Subject: PG&E Fulton-Fitch Mountain APPLICATION NO. A.15-12-005
Date: Friday, January 22, 2016 5:03:55 PM
Attachments: [Deficiency Rpt #1 Response Table 1-22-16 FIN.doc](#)

PG&E DEFICIENCY RESPONSE #1 JANUARY 22, 2106 - TRACKING TABLE: DEFICENCY REPORT #1 – DECEMBER 23, 2015

DEFICIENCY REPORT #1 FOR THE PG&E FULTON-FITCH MOUNTAIN RECONDUCTORING PROJECT – APPLICATION NO. A.15-12-005

Figure NS-01(1): Representative Residential Locations

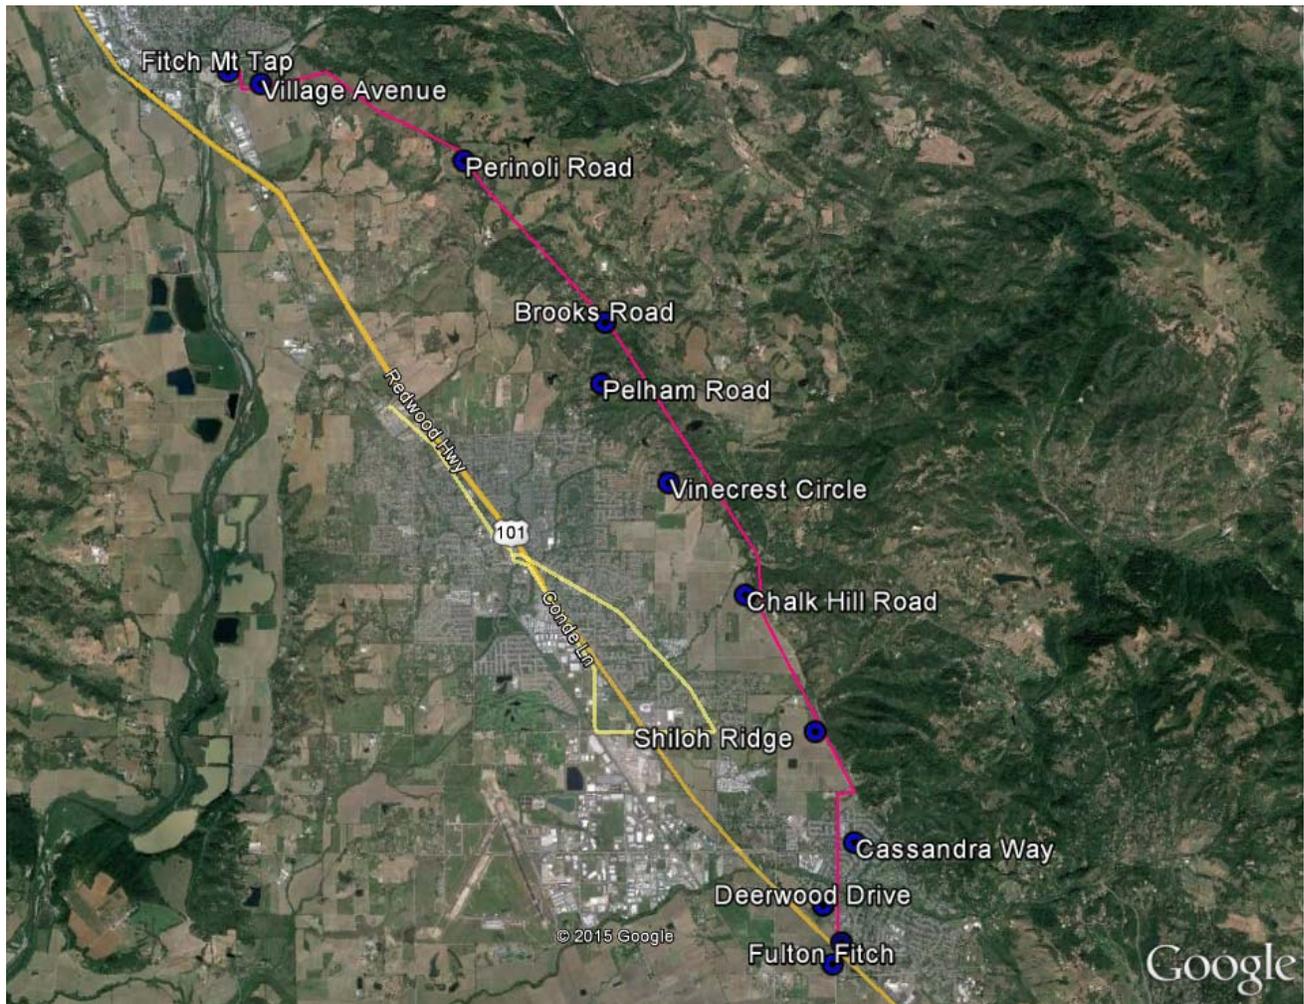
Discussion NS-01

Existing ambient noise levels in the vicinity of the substations and along the transmission line were estimated by determining the land uses in each area through a review of aerial photography. Ten residential locations were chosen along the proposed transmission line (Figure 1), and the ambient sound levels were estimated for those areas. The ambient sound levels were also estimated for the residences directly surrounding the Fulton and Fitch Mountain Substations. Table 4. NS-01: Project ANSI Land Use Categories and Estimated Ambient Noise Levels lists these representative locations, the estimated ANSI land use category, and the expected ambient sound levels.

Large sections of the proposed transmission line are in rural areas, with very few residences nearby. The majority of residences are located in Categories 2 and 3 land uses.
